UNITED STATES PATENT AND TRADEMARK OFFICE

10/801,750

Office Action Summary	Application No.	Applicant(s)	
	10/801,750	YURKOVICH, RUDOLPH N.	
	Examiner	Art Unit	
	Timothy D. Collins	3643

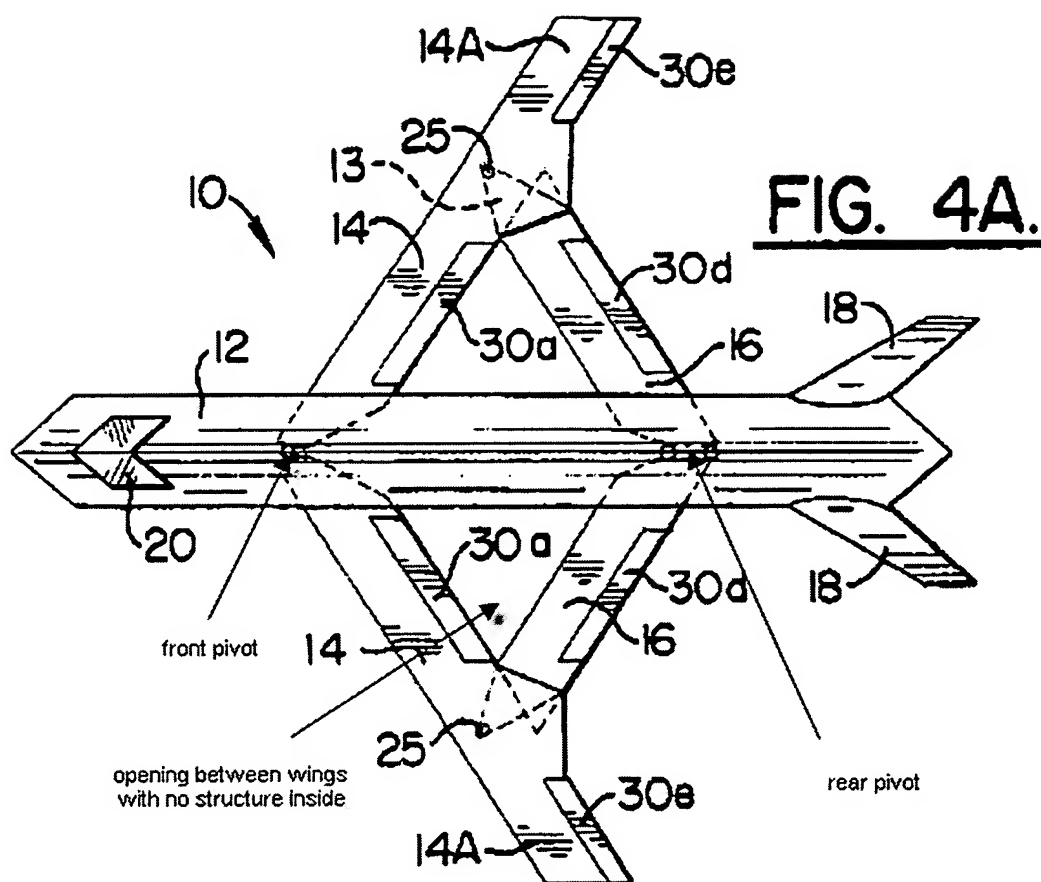
a. Re claim 1, 410 discloses a vehicle 10 with a left side forward wing section (14 on the left), and a right side forward wing section (14 on the right) which is connected to the left side for movement between first and second positions see figures 4a (first) and 4b (second). Also a left side and right side rearward wing section (16 on the left and right). The left and right rearward wings being moveable between first and second relative positions see 4a and 4b. The wings being connected together for movement, with an opening between the left and right forward wings and also between the left and right rearward wings. The opening is seen in the figure 4a at least, in that between the left forward and rearward wings the opening is also between the right forward and rearward wings, the opening on the left side of the craft is the one referenced. The opening can be seen to be between all the wings, however it is closer to the ones on the left side in the given case. See below modified figure.

c. Re claim 3, 410 discloses a forward pivot assembly as seen in the figure above.

d. Re claim 4, 410 discloses a rearward pivot assembly as seen in the figure above.
